**ČSN
EN 61924-2
OPRAVA 1**

**Maritime navigation and radiocommunication equipment and systems –
Integrated navigation systems –
Part 2: Modular structure for INS –
Operational and performance requirements, methods of testing
and required test results**

CORRIGENDUM 1

Clause K.2 ACM – Alert command

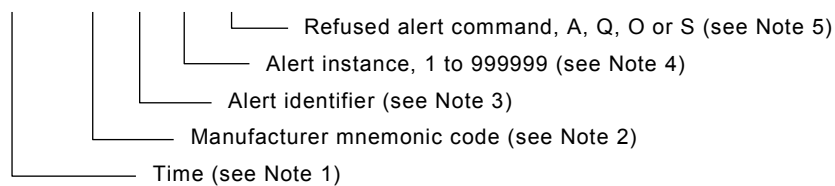
Replace, in the title and the sentence definition (fourth paragraph) ACM by ACN as follows:

K.2 ACN – Alert command

\$--ACN,hhmmss.ss, aaa, x.x, x.x, c, a*hh <CR><LF>

Figure J.1 – Legacy sensor communication showing priority reduction

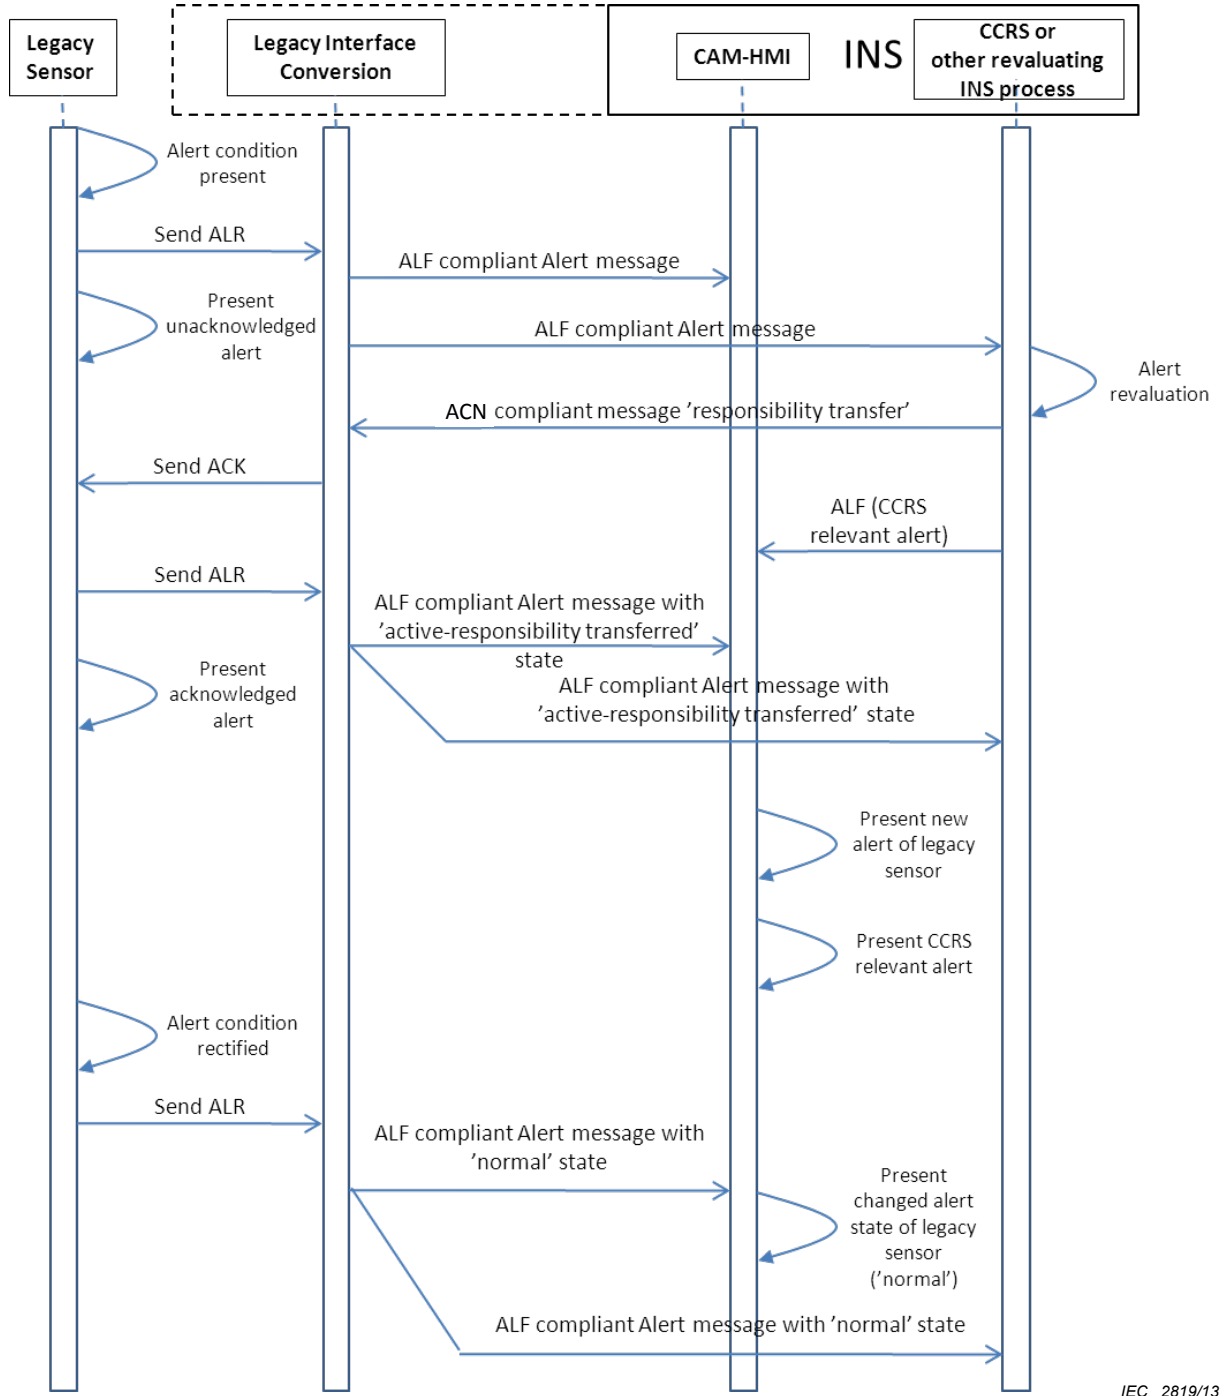
Replace ACM by ACN in the following clauses, subclauses, tables and figures:

J.3.2	1 st paragraph	
Table J.1	6 th row	
Table J.1	7 th row	
Table J.2	Title	
Table J.2	1 st row, column title	
J.3.2	example below Table J.2	1 occurrence
Figure J.1		1 occurrence, see below
J.3.3	1 st paragraph, below Figure J.1	
J.3.4	1 st paragraph, below Figure J.2	
Clause J.4	Title	
J.4.1	1 st paragraph	2 occurrences
Figure J.3		1 occurrence, see below
Figure J.4		1 occurrence, see below
J.4.6	Title	
J.4.6.1	1 st paragraph	
J.4.6.2	1 st paragraph	
Figure J.5		8 occurrences, see below
Clause K.3	2 nd paragraph	
L.1.1	1 st paragraph
